A 6 9 2

Fig. 4. Schematic of the A-692 amplifier-speaker. Note the compensation network and tone control in the feedback circuit.

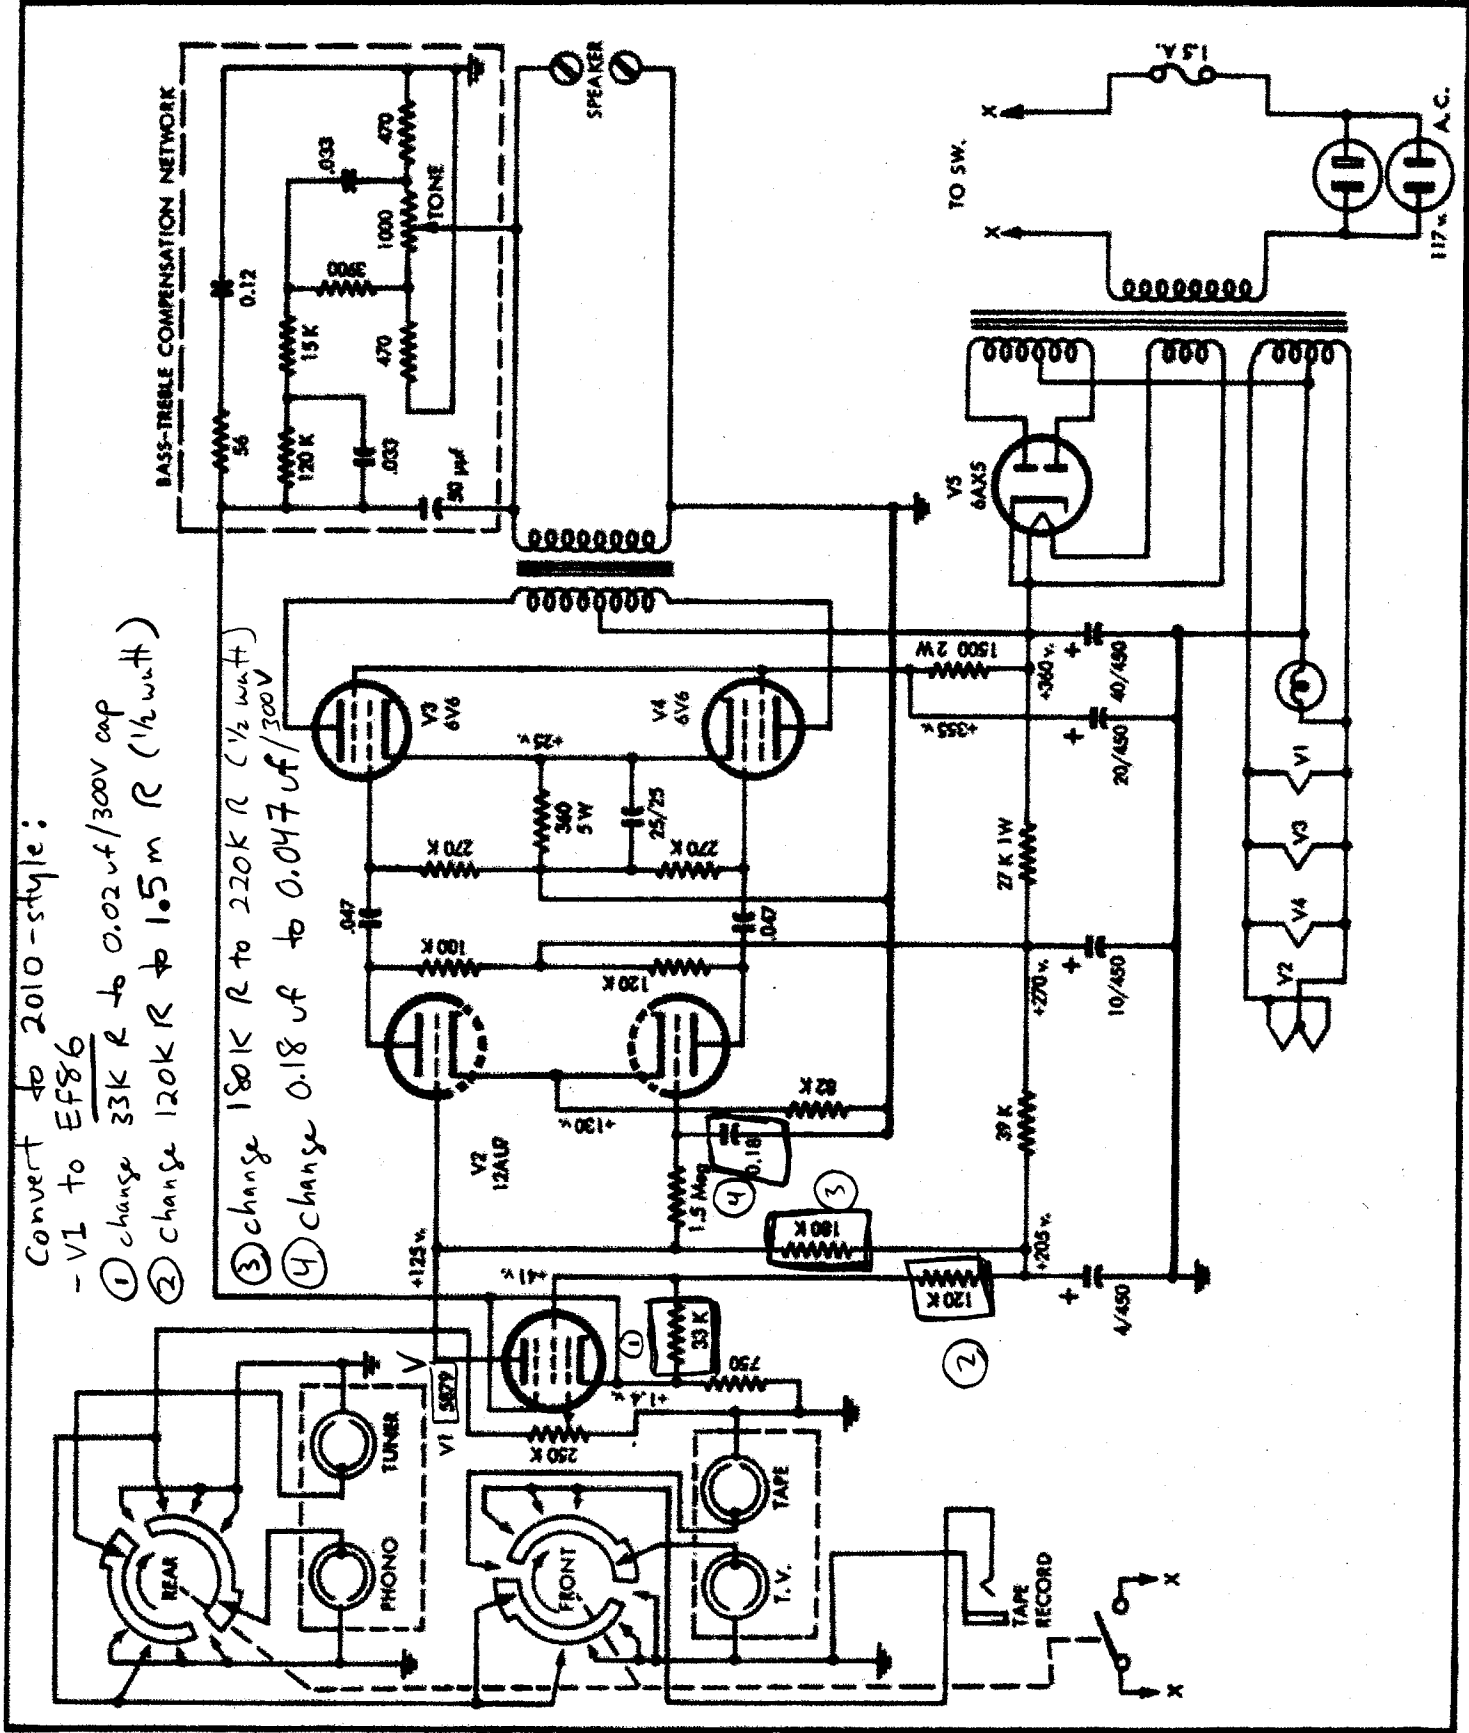
- Convert to 2010-style:
 - V1 to EF86
 ① change 33K R to 0.02 uf/300v cap
 ② change 120K R to 1.5 m R (1/2 watt)
 ③ change 180K R to 220K R (1/2 watt)
 ④ change 0.18 uf to 0.047 uf/300v
